## COUNCIL ASSESSMENT REPORT

Panel Reference	PPSSTH-99
DA Number	DA-2021/957
LGA	Wollongong City Council
Proposed Development	Demolition of existing structures, retention of heritage facades, tree removal, excavation for basement car parking and construction of a mixed-use development at the street block bound by Crown, Keira, Burelli and Atchison Streets, comprising three (3) residential towers (shop top housing), one (1) commercial building, retail shops, entertainment facilities (cinema, exhibition/performance space) and a wellness centre (pool, gym, and health services)
Street Address	216-222, 226-238 Keira Street, WOLLONGONG, 86 Burelli Street, WOLLONGONG, Lot B Burelli Street, WOLLONGONG, Lot 1 and Lot 2 Burelli Street, WOLLONGONG, 221-261, 269-291 Crown Street, WOLLONGONG NSW 2500
Applicant/Owner	Chris Halios-Lewis - Birketu Pty Ltd / Crown Street Wollongong Holdings Pty Ltd ATF Crown Street Holdings Unit Trust
Date of DA lodgement	24 August 2021

S4.15 Assessment Report and Recommendation  
**DA-2021/957 | PPSSTH-99**

**Figure 12: View from unit 1802 in Avante building**

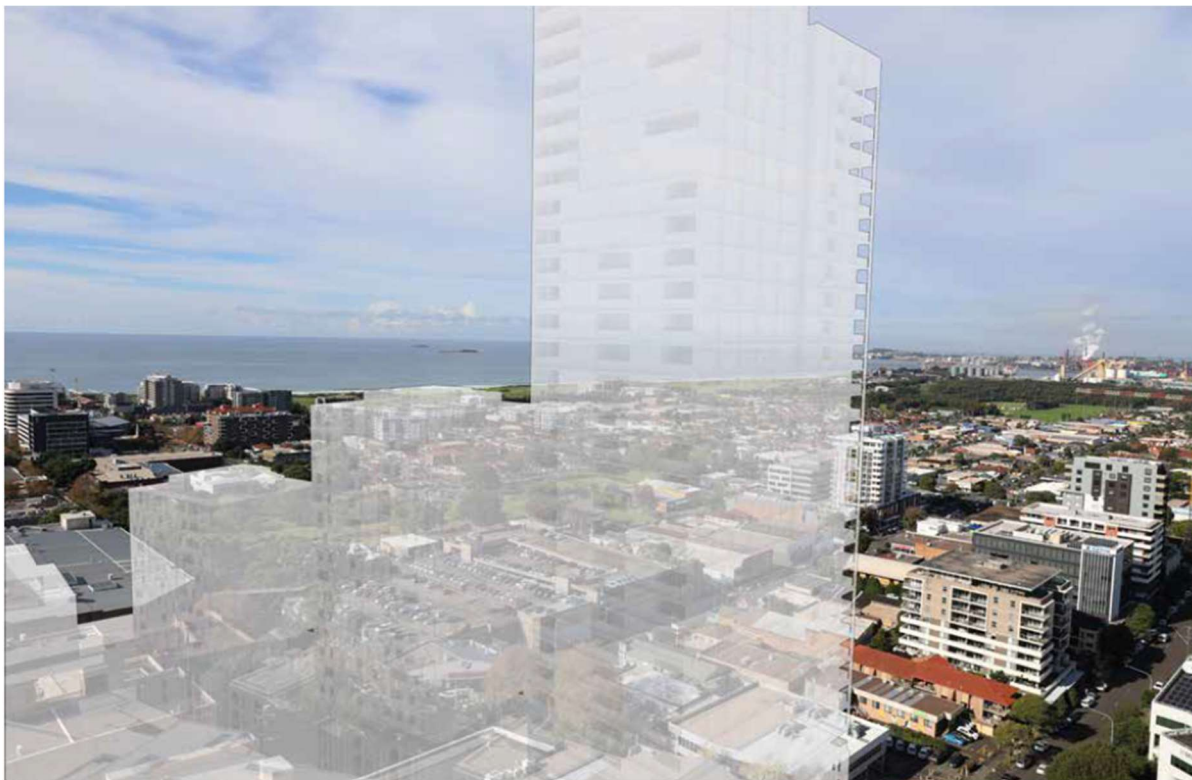
Views to be impacted are distant views toward the coastline and horizon as illustrated at Figure 12 Figure 13 below. Panoramic views towards the coast are currently available from the higher levels of the Avante building.

**Figure 15: Height variation in section viewed from Burelli Street**

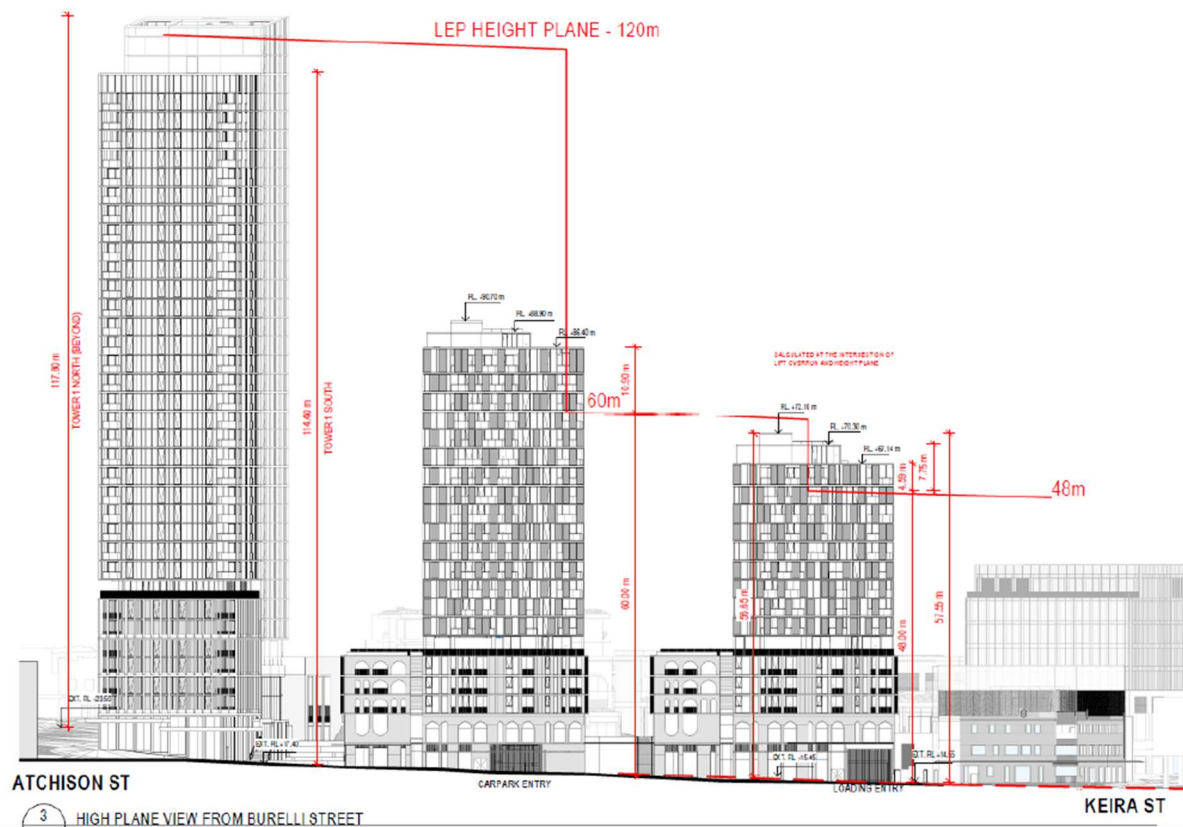
In regard to height, towers 2 and 3 exceed the height limit for parts of the upper levels, three storeys for tower 2 and two storeys for tower 3 as shown at Figure 15 and Figure 16.

The height variation for Tower 2 is inconsequential given the narrowness of the portion that does not comply. At the point of non-compliance the building separation complies between Tower 2 and Tower 3.

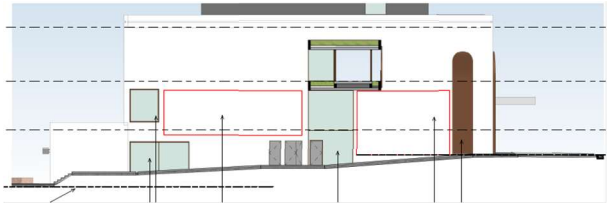
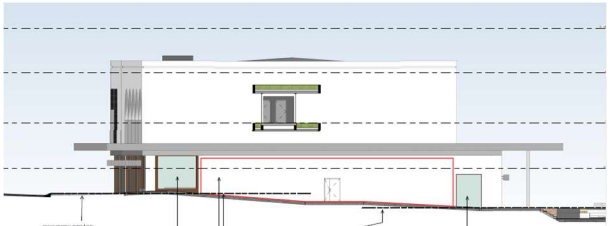
<p>Further resolution of commercial building at corner of Crown and Keira St with regard to street interface (awning, retail entry, balcony, blank wall treatment, art etc.)</p>	<p>It is noted this corner is a prominent one within the city centre with a steep grade change from Crown wrapping around to Keira Street, and high pedestrian traffic volumes.</p> <p>In looking at how best to respond to the characteristics of the corner, the design has evolved from an open plaza (concept scheme), to an elevated building with permeable terraced undercroft area, to the current layout which has the building meeting the ground.</p> <p>The redesign has also involved the relocation of the cinema to below ground and extending above ground at this corner.</p> <p>Providing a direct entry into the building at the corner is not considered feasible with the current design.</p> <p>In terms of interface with the street, the proposal satisfies clause 7.13 of the LEP in terms of street activation, having a direct entry from Keira Street</p>

<p>and large glazed areas to both Keira and Crown Street.</p> <p>Pedestrian weather protection could be improved through extension of the awning to the corner of the building on the Keira Street elevation and this is addressed through a condition of consent.</p> <p>The exposed edge of the cinema does present a blank façade to a portion of the Keira Street elevation where cinema advertising and/or poster treatment is proposed. This is considered to be acceptable in the context of the extent of this blank wall in the overall scheme. The section facing Crown Street includes a terraced area with landscaping to soften the impact of the podium.</p>
Consideration to materials enclosing the terrace to the exhibition space above The Grand, particularly with regard to maintaining an outlook to MacCabe Park.	<p>The exhibition space has a terrace area on the southeast corner which has a perforated screen wrapping around the elevation. The screen provides a continuity and solidity of the building edge that is an appropriate response to the façade of The Grand being retained below.</p> <p>Whilst the screen will not provide unobstructed views towards the park, it will allow some outlook. It is also noted the elevated pedestrian walkway over Burelli Street would partially obscure this view in any case.</p>

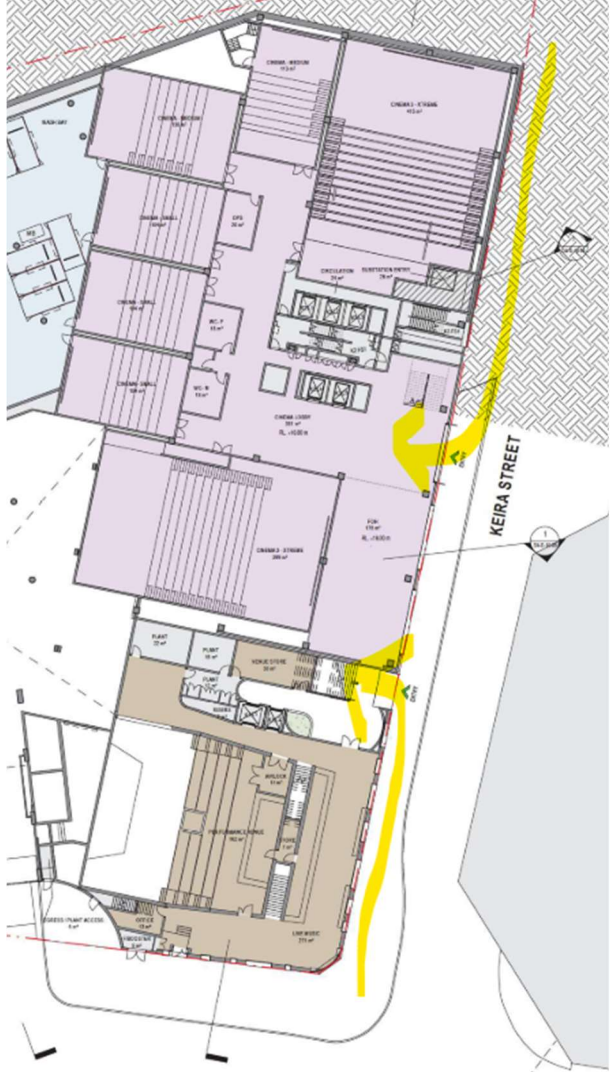
<p>Programming of central dead end plaza space</p>	<p>The area in question is highlight in an excerpt from the Landscape Plan below.</p>  <p>This area as shown would be a general seating area only.</p> <p>There are opportunities for additional windows from the adjacent retail tenancies to better activate this space and facilitate it's potential use for outdoor dining. A condition of consent is recommended that windows be provided on the plaza level elevations.</p>
<p>Accessible path of travel to entry points along Keira Street.</p>	<p>The gradient between the corner of Crown and Keira Streets and the new lift entrance ranges from 1:9 at the corner to 1:23 near the entrance to the lift and hence, is non-compliant for a large portion of the Keira Street footpath. The gradient between the corner of Keira and Burelli Streets and the new lift entrance is approximately 1:23.</p>

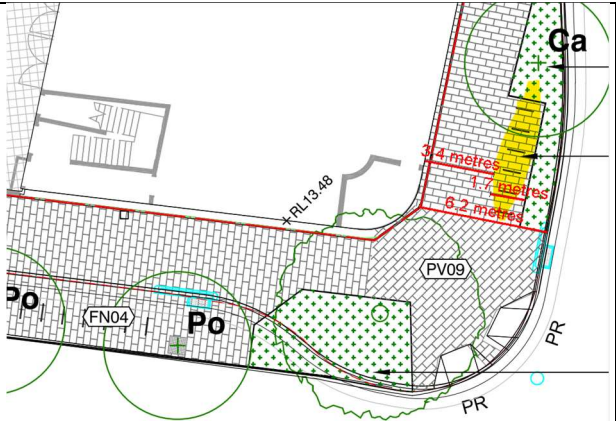
<p>The non-compliant footpath grades are a matter out of the control of the developer.</p> <p>It is noted accessible paths of travel and lifts are provided at numerous points around the perimeter. This includes a lift at the corner of Atchison and Burelli, level transition to the entry to the plaza from Crown Street, level transition to the central lane on Crown Street, a lift at the laneway adjacent to the Marcus Clark building, and level entry into the residential foyers.</p>
<p>Potential clash of bicycle racks with pedestrian path of travel adjacent The Grand</p>	<p>The bike racks in question are highlighted below.</p>

<p>The exact final location of bicycle racks within the footpath is to be resolved in consultation with Council prior to the issue of the CC.</p>

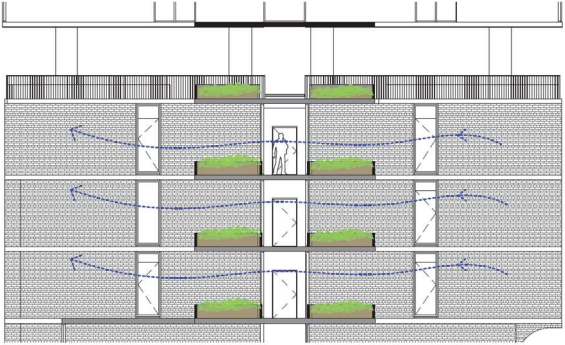
<p>The suns eye view diagrams provided do not appear to be providing a true and accurate representation of the location of the sun. An accurate solar study must be provided to allow ADG solar access requirements to be assessed. Suns eye view diagram should also show the extent of solar access to the full extent of the public domain within the development.</p>	<p>Revised suns eye view diagrams have been submitted. An assessment against the ADG has been completed and is contained at <b>Attachment 8</b>. It is noted that there are a number of units within level 2-4 of Towers 2 and 3 that could be readily amended to include additional windows or different balcony treatments to improve solar access and natural light. This is to be addressed via conditions.</p>
<p>If the slots in the buildings are to be accepted as meeting the ADG objectives for cross ventilation, the Panel recommends that site specific modelling is undertaken to demonstrate this.</p>	<p>The applicant provided a natural ventilation report prepared by RWDI and a supplementary memo was submitted by RWDI in response to this concern.</p> <p>This does however fail to account for proposed louvres to the breezeways.</p>  <p>A condition of consent is recommended with regard to any louvres being required to be fixed in an open position (see condition 23).</p> <p>Site specific modelling included in the ventilation report concluded that after taking into account the assumptions for the pressure loss coefficients, the apartments assessed (Types 1C and 2A) are naturally cross ventilated in accordance with AS1668.4 and the City of Sydney Natural Ventilation Guidelines (used for reference as Wollongong Council has no guidelines on Cross Ventilation).</p>

**Figure 19: South-eastern units in Tower 2 (highlighted) which can achieve 2 hours solar access with a highlight or pop-out window between 10am-12pm**

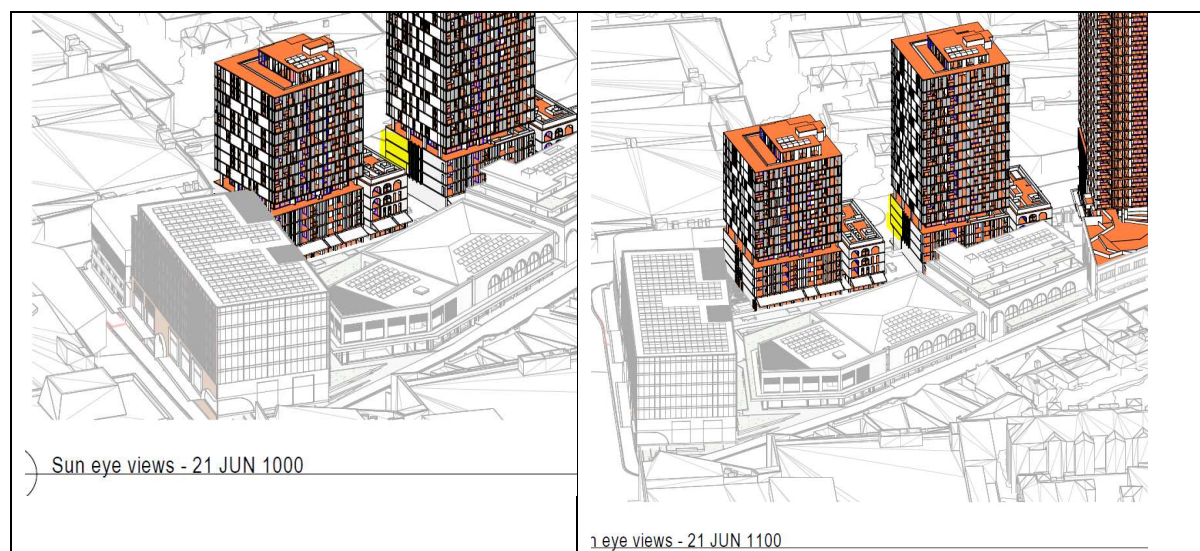
Discounting the above 6 units results in 69/107 units receiving the minimum 2 hours sunlight access to living areas and balconies (65%). With additional windows to 6 units on the eastern elevation (2.05, 2.06, 3.05, 3.06, 4.05, and 4.06), including the south-eastern units not currently identified as receiving solar access, the minimum 70% is achieved. These windows will need to be designed to provide solar access while limiting direct sightlines and noise transfer between buildings (e.g. high sill windows, pop-out windows, all acoustically treated).

**Figure 20: Sun-eye view diagrams 1pm-3pm on 21 June showing location of additional windows to improve solar access to Tower 3.**

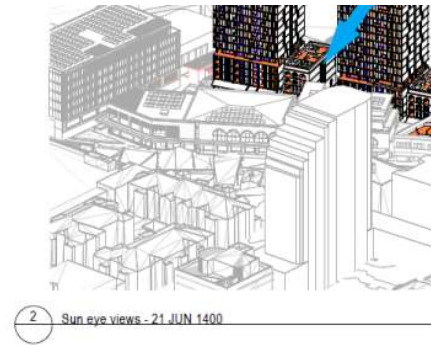
To include the units on Levels 3 and 4 as achieving the 2 hours, highlight windows will be required to achieve solar access between 1-3pm in midwinter, as shown at Figure 20 below:
